STATE OF WASHINGTON  
**DEPARTMENT OF ECOLOGY**

**Re: Terminals 5 6 & 7 Uplands Draft Agreed Order and Draft Remedial Investigation Work Plan Comments**

- **Site Name:** Terminals 5 6 & 7 Uplands, Port Angeles, Clallam County, WA
- **Site Address:** Marine Drive, Port Angeles, Clallam County, WA
- **Facility/Site No:** 97700
- **Cleanup Site ID No.:** 15440

### ***Additional Shoreline Monitoring Wells***

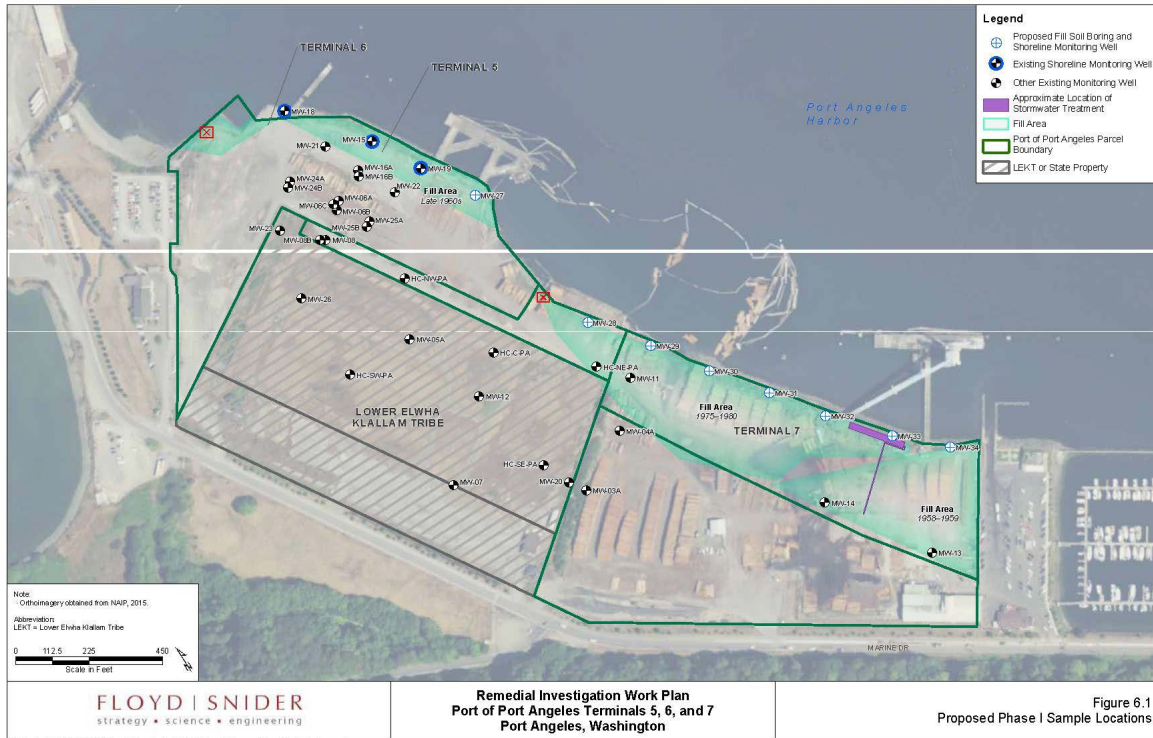
Ecology requests two additional shoreline monitoring network wells to fill data gaps in the network shown by red X's in the figure below. Both of these locations are in known historical fill locations; however, the depth of known fill is less than the depth of the proposed monitoring wells. It is possible the installation of these wells will encounter native soil or sediment below the fill.

Ecology consulted with the Lower Elwha Klallam Tribe (LEKT) and they verbally agreed that the well location between MW-27 and MW-28 would be acceptable considering cultural resources. The location west of Terminal 6 is under consideration by the LEKT. These wells are important for understanding the nature and extent of contamination within the Study Area, to understand source control measures necessary to protect Western Port Angeles Harbor, and to support potential, future, shoreline restoration efforts.
